PROJECT PLANS FOR CONSTRUCTION ON
STATE HIGHWAY
IN PLACER COUNTY
AT VARIOUS LOCATIONS
FROM SOUTH ROSEVILLE OVERCROSSING
TO WEIMAR CROSS ROAD OVERCROSSING

2 REVISED PER ADDENDUM NO. 2 DATED FEBRUARY 25, 2011

CONTRACT No.	03-3E0904
PROJECT ID	0300000472

NEAR ROCKLIN UNDERCROSSING
PM 5.73 TO 6.40

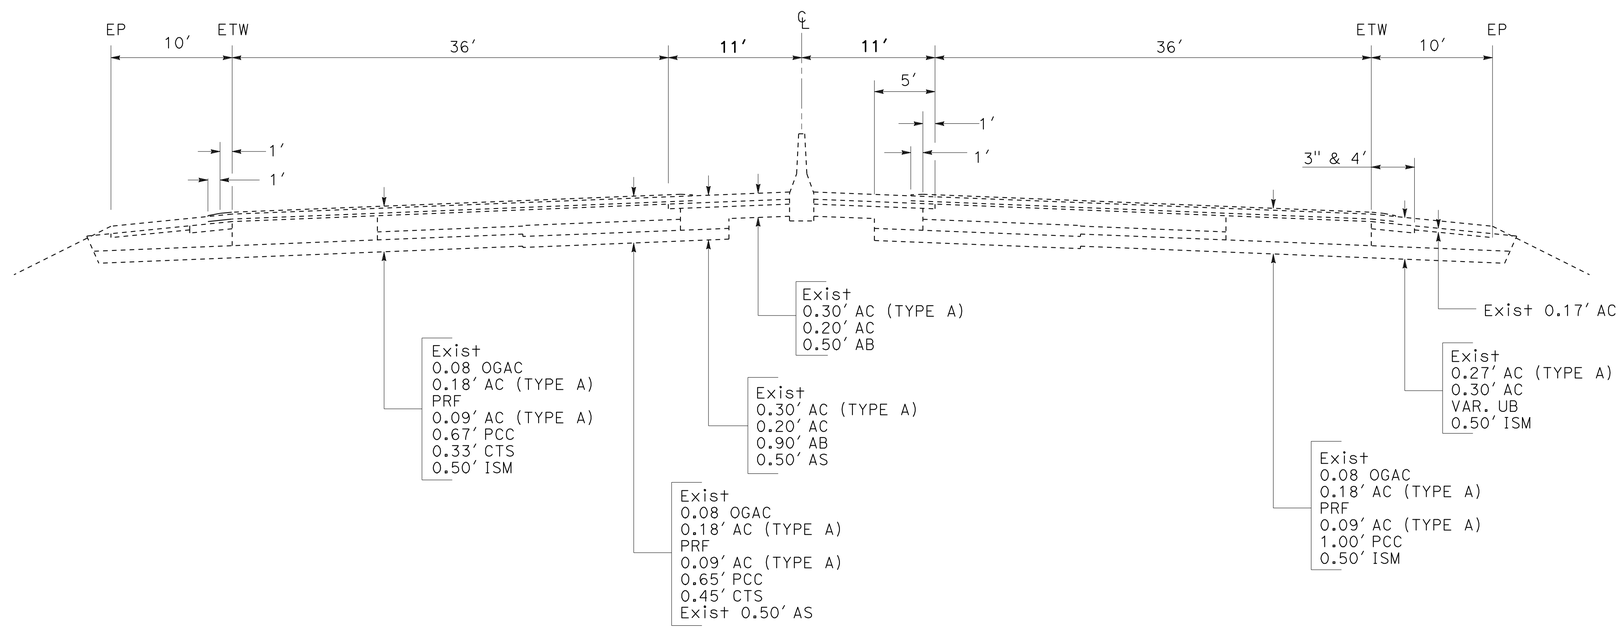
1. FOR INFORMATION ONLY. NO ROADWAY WORK AT THIS LOCATION.
   SEE STRUCTURES PLANS FOR STRUCTURE WORK AT THIS LOCATION.

2 **ADDED PER ADDENDUM No. 2 DATED FEBRUARY 25, 2011**

~~PLACE HMA (Misc AREA) AT EXISTING DI AT WEIMAR OH WB PM 28.70~~

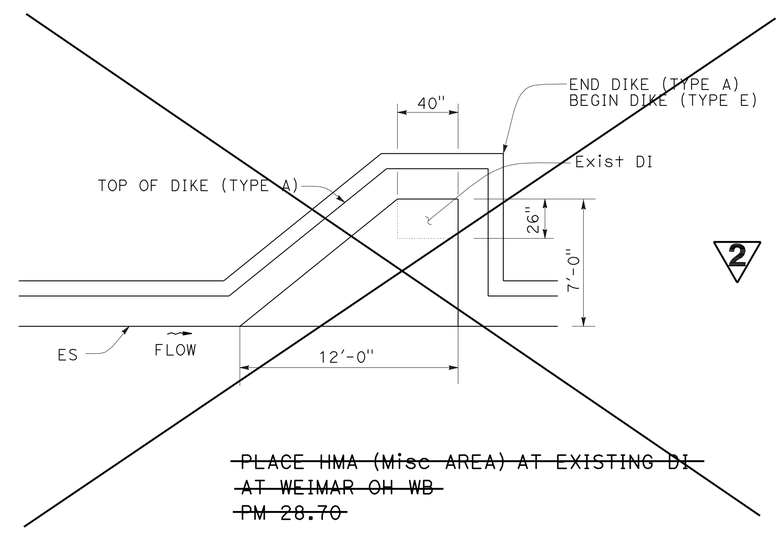
2 **REVISED PER ADDENDUM No. 2 DATED FEBRUARY 25, 2011**

DETAIL A

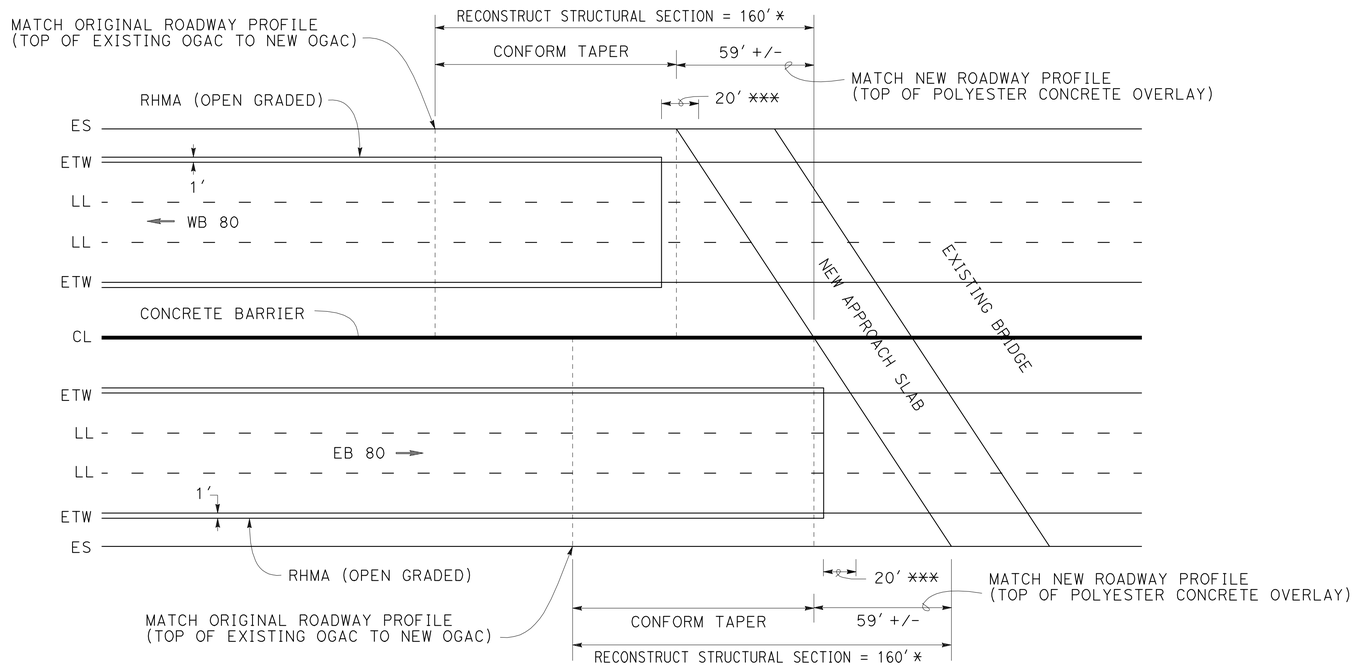
SKEWED APPROACH SLABS AT BOWMAN OVERHEADS ONLY.
CONFORM HMA (TYPE A) TO POLYESTER CONCRETE OVERLAY.
RHMA (OPEN GRADED) EXTENDS TO ES WHEN ES IS HIGHER THAN ETW.

2 **ADDED PER ADDENDUM No. 2 DATED FEBRUARY 25, 2011**

LOCATION 6 ~~& 7~~ 2

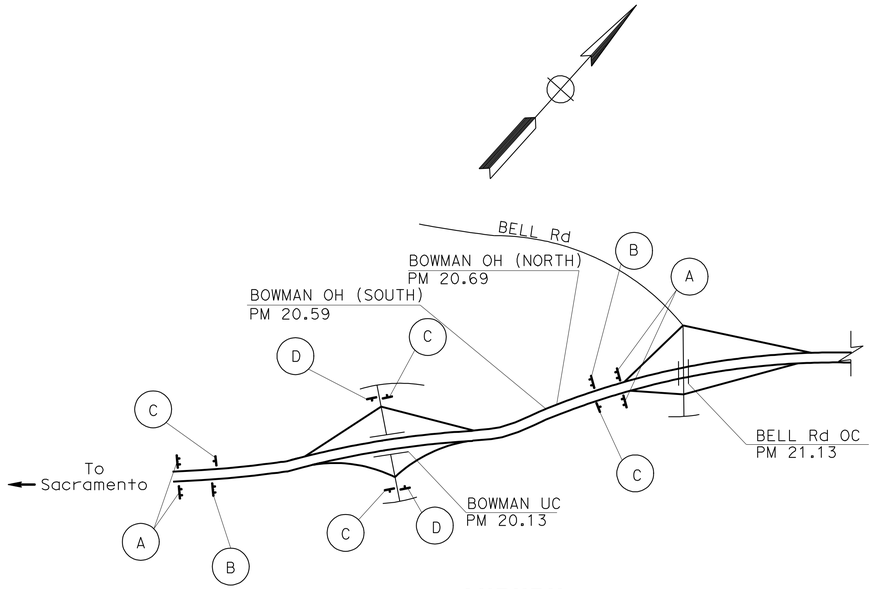
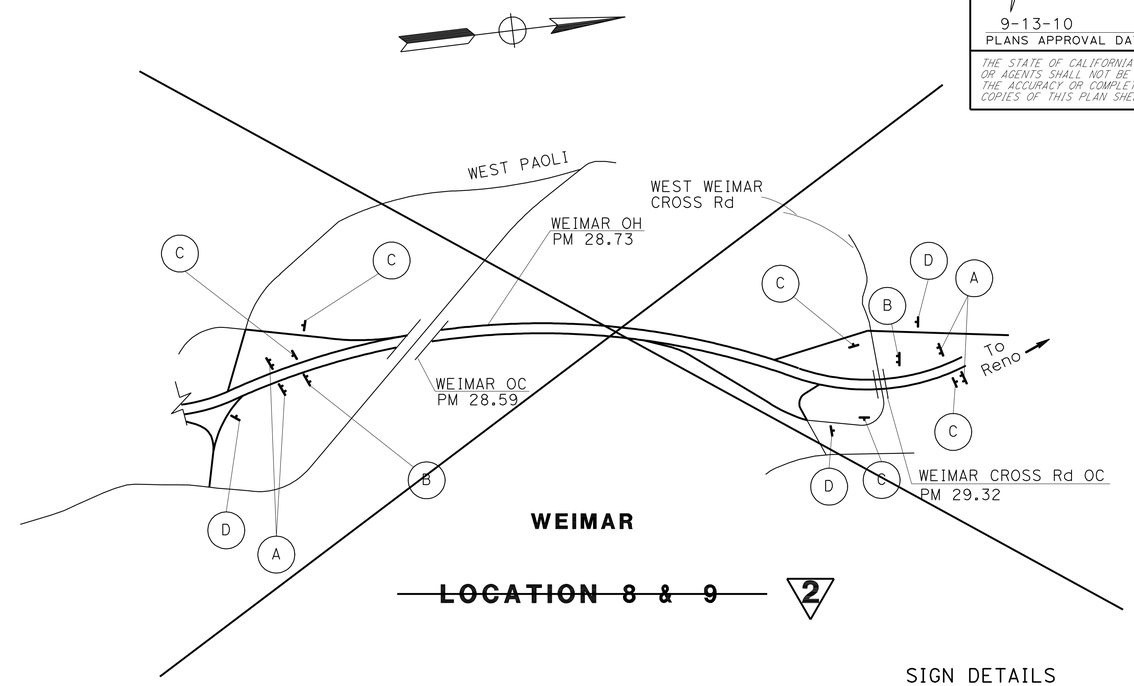
~~**LOCATION 8 & 9**~~ 2

2 **REVISED PER ADDENDUM No. 2 DATED FEBRUARY 25, 2011**

CONFORM AT STRUCTURES - STAGE 1A AND 1B

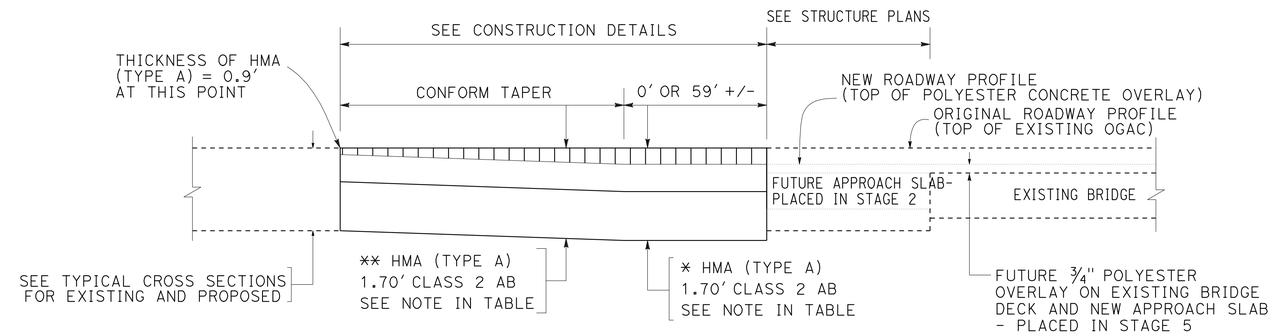
DEPTH OF EXCAVATION AND THICKNESS OF HMA (TYPE A) PLACED IN STAGE 1 SHALL BE ADJUSTED AS REQUIRED TO PROVIDE 0.8′ HMA (TYPE A) AFTER COLD PLANING OPERATIONS IN STAGE 2, OR AS DIRECTED BY THE ENGINEER.

2 **REVISED PER ADDENDUM No. 2 DATED FEBRUARY 25, 2011**

STAGE 1A

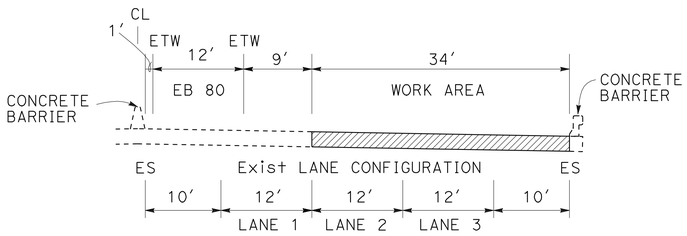
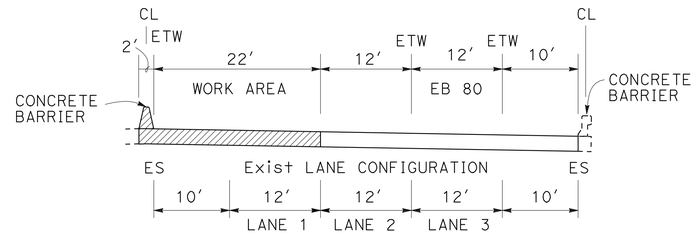
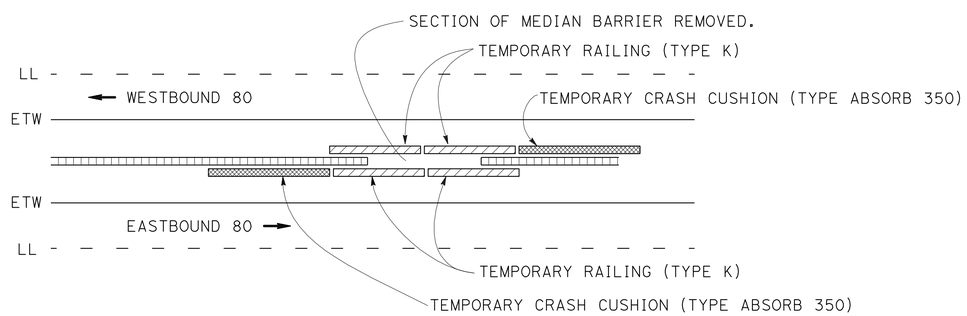
REPLACE EASTBOUND APPROACH AND DEPARTURE SLABS UNDER LANES 2 AND 3, AND OUTSIDE SHOULDER.

REPLACE EASTBOUND APPROACH AND DEPARTURE SLABS UNDER LANE 1 AND INSIDE SHOULDER, INCLUDING PORTION UNDER MEDIAN BARRIER. REPLACE MEDIAN BARRIER REMOVED TO ALLOW FOR SLAB REPLACEMENT. SEE DETAIL A.

PROTECT TRAFFIC FROM OPENING IN BARRIER. TEMPORARY RAILING (TYPE K) SHALL REMAIN IN PLACE UNTIL CONCRETE IS CURED OR AS DIRECTED BY THE ENGINEER.

2 **ADDED PER ADDENDUM No. 2 DATED FEBRUARY 25, 2011**

CONFORM AT STRUCTURES - STAGE 2A AND 2B

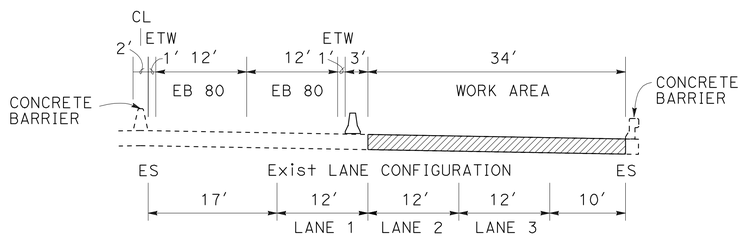
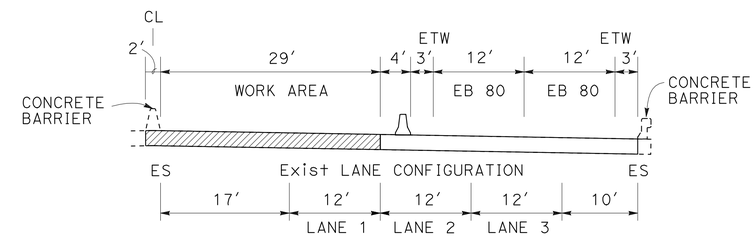
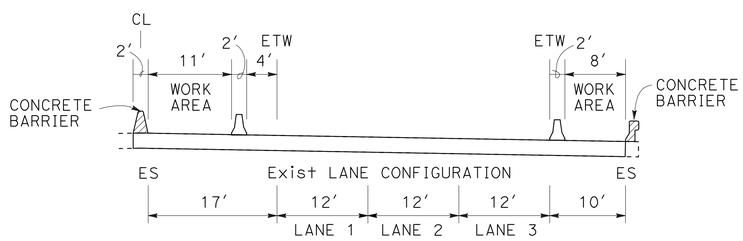
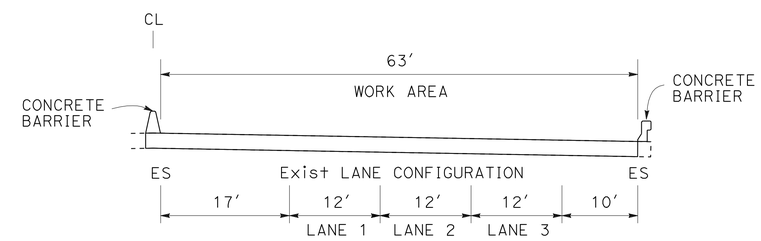
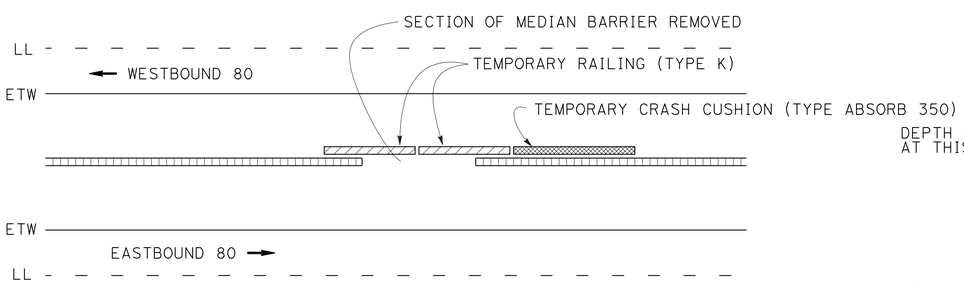
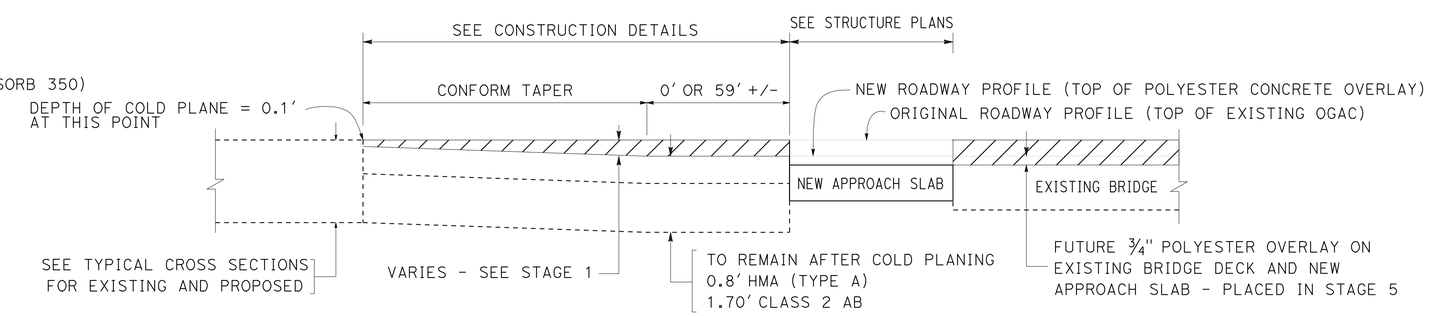
STAGE 2A AND 2B - IN ONE 60 HOUR CLOSURE WINDOW, PLACE NEW EASTBOUND APPROACH AND DEPARTURE SLABS, REMOVE AC SURFACING FROM BRIDGE DECK, AND COLD PLANE OVERBUILT STRUCTURAL SECTION AT CONFORM TAPER. SEE DETAIL A AND CONFORM AT STRUCTURES - STAGE 2A AND 2B DETAIL THIS PAGE, AND STRUCTURE PLANS.
STAGE 3 - REPLACE MEDIAN BARRIER REMOVED IN STAGE 2B. REPLACE EASTBOUND CONCRETE BRIDGE BARRIER ON OUTSIDE SHOULDER.
STAGE 4 - COLD PLANE HMA PAVEMENT AND PLACE RHMA (OPEN GRADED) ON EASTBOUND LANES.
STAGE 5 - PLACE POLYESTER CONCRETE OVERLAY ON EASTBOUND LANES.

PROTECT TRAFFIC FROM OPENING IN BARRIER. TEMPORARY RAILING (TYPE K) SHALL REMAIN IN PLACE UNTIL NEW CONCRETE BARRIER IS CURED OR AS DIRECTED BY THE ENGINEER. STAGE 3 TEMPORARY RAILING (TYPE K) WILL PROTECT EASTBOUND TRAFFIC.

2 **ADDED PER ADDENDUM No. 2 DATED FEBRUARY 25, 2011**

CONCRETE BARRIER TYPE 50A

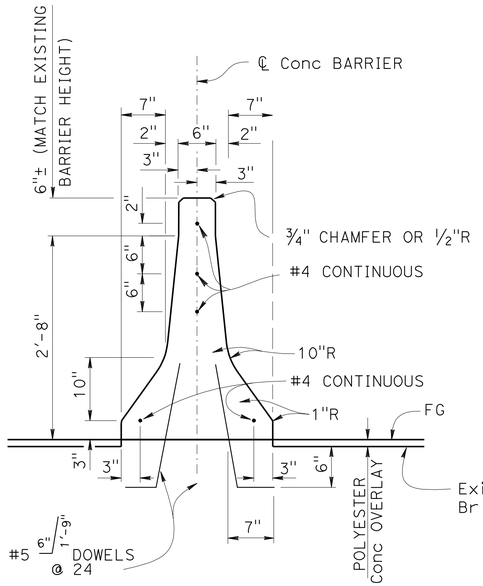
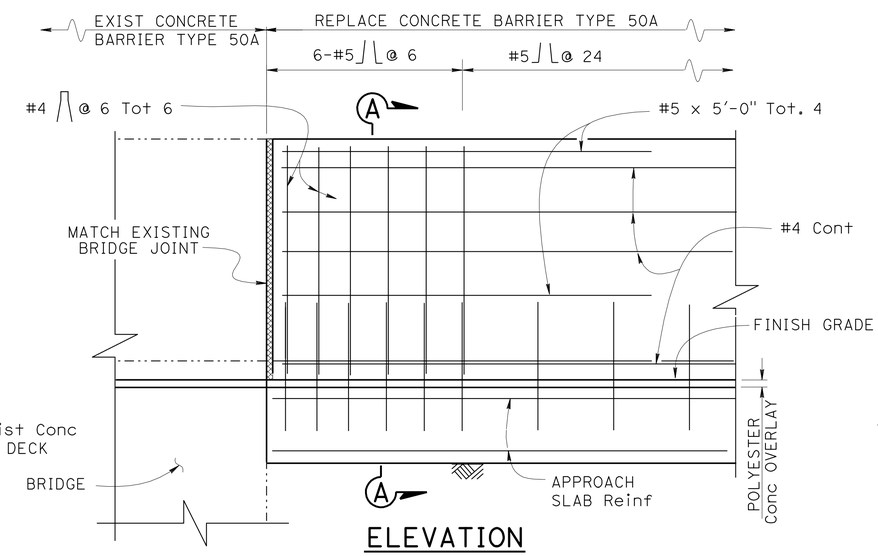
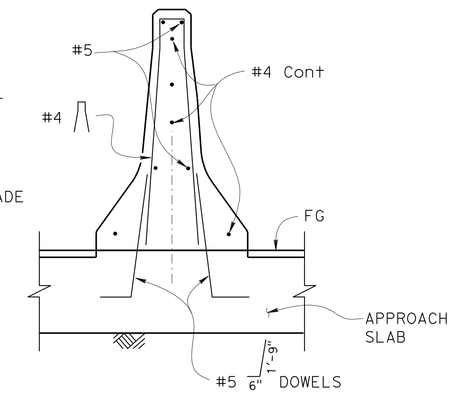
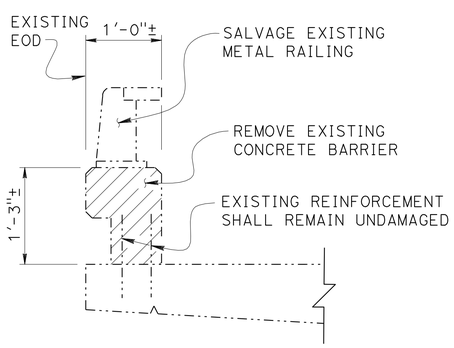
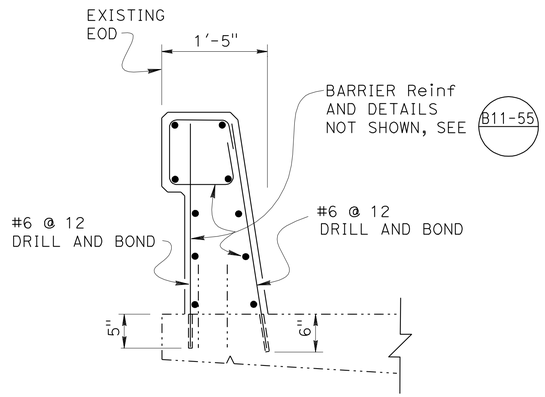
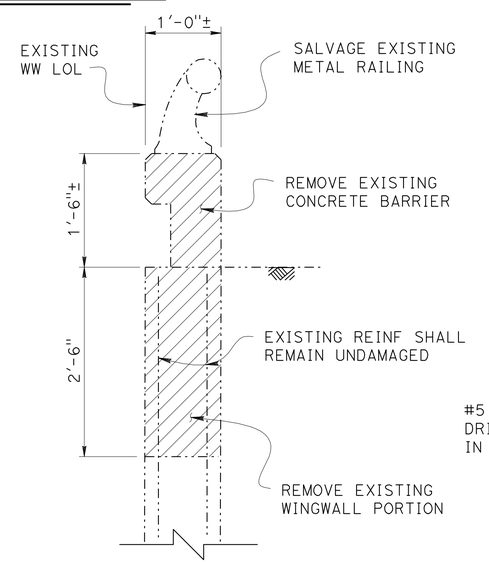
1. WINGWALL AND CONCRETE BARRIER REINFORCEMENT SHALL BE EPOXY COATED FOR:
   BOWMAN UC Br No. 19-0042
   BOWMAN OH (SOUTH) Br No. 19-0023
   BOWMAN OH (NORTH) Br No. 19-0024

2 ADDED PER ADDENDUM No. 2 DATED FEBRUARY 25, 2011

EXTERIOR GIRDER REPAIR DETAIL

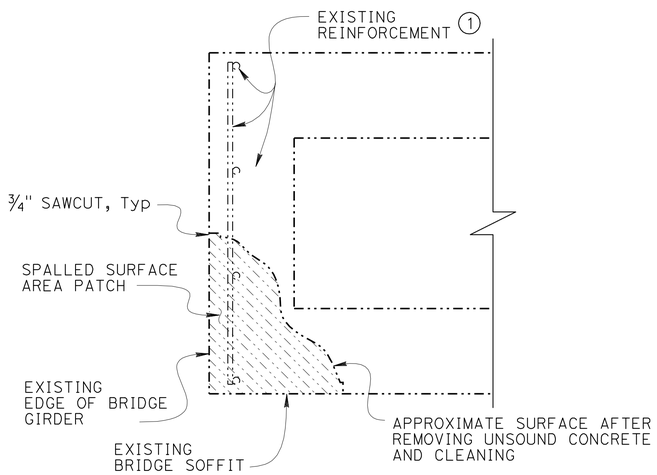
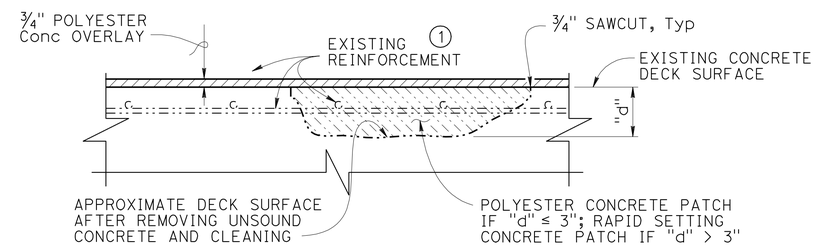
REMOVE UNSOUND CONCRETE AND PATCH WITH RAPID SETTING CONCRETE

2 **ADDED PER ADDENDUM No. 2 DATED FEBRUARY 25, 2011**
